TECHNICAL BULLETIN
Bell Helicopter **TEXTRON**
A Subsidiary of Textron Inc.

NO 407-00-25

SUBJECT: FUEL SYSTEM ANTI-ICING ADDITIVE DECAL
P/N 31-056-18EFHP, REMOVAL OF.

HELICOPTERS AFFECTED: 407, S/N 53000 through 53402

Figure 1. – Decal 31-056-18EFHP - Removal

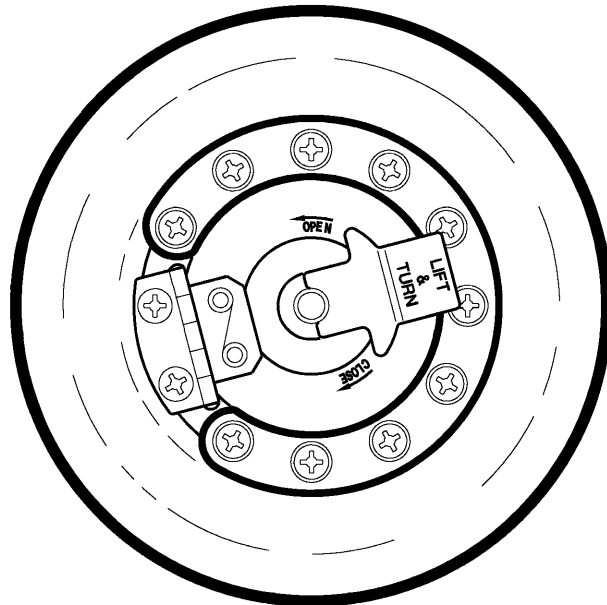
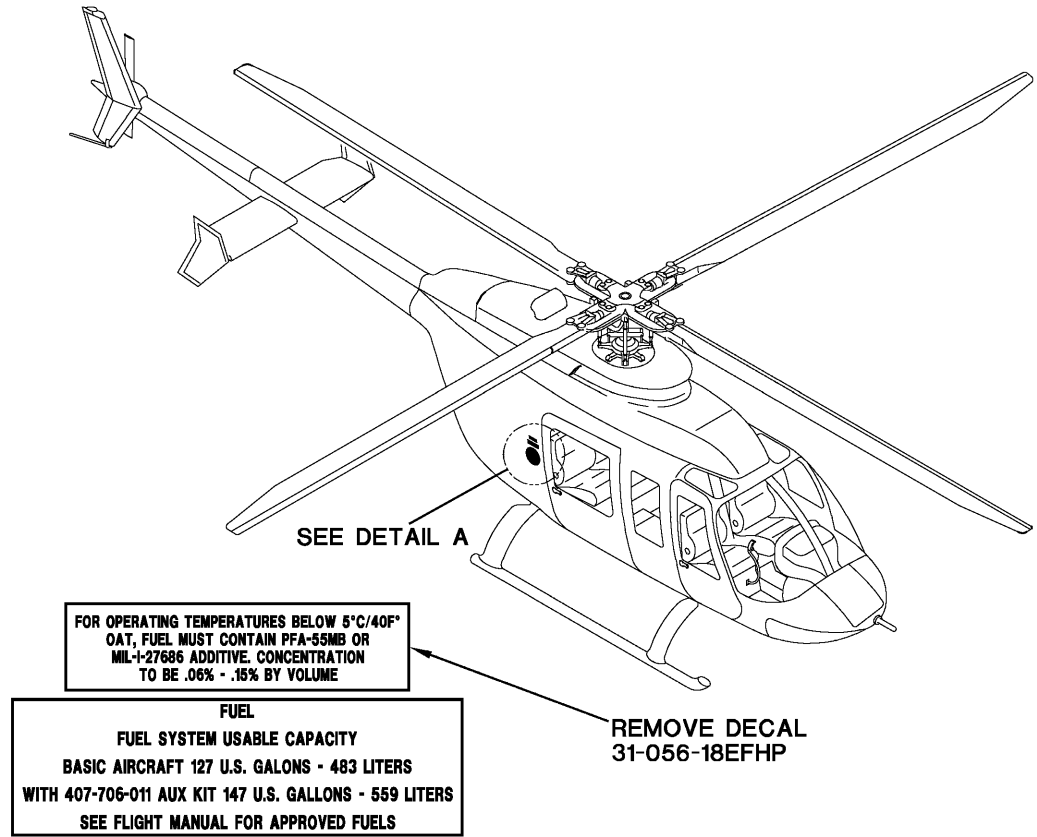
Revision 6 of the 407 Flight Manual (BHT-407-FM-1) dated July 3, 1998, removed the limitation which required the use of anti-icing fuel additives for approved fuels below 5° C (42° F). As it is no longer necessary to use anti-icing fuel additives for approved fuels, this bulletin gives the authority and procedure to remove anti-icing additive decal P/N 31-056-18EFHP. The decal is located above the fuel filler cap.

1. Find the location of anti-icing additive decal P/N 31-056-18EFHP (Figure 1).

Do not remove Fuel System Usable Capacity decal located directly above fuel filler cap.

2. Take care not to damage the paint under the anti-icing additive decal, and carefully lift one corner of the decal with a very sharp knife blade (i.e. x-acto knife or razor blade etc.).
3. To remove the decal, grasp the lifted corner with your fingers and pull it slowly but firmly towards you.
4. If the adhesive from the decal is left on aircraft surface, remove it with clean cloth moistened with Aliphatic Naphtha (C-305).
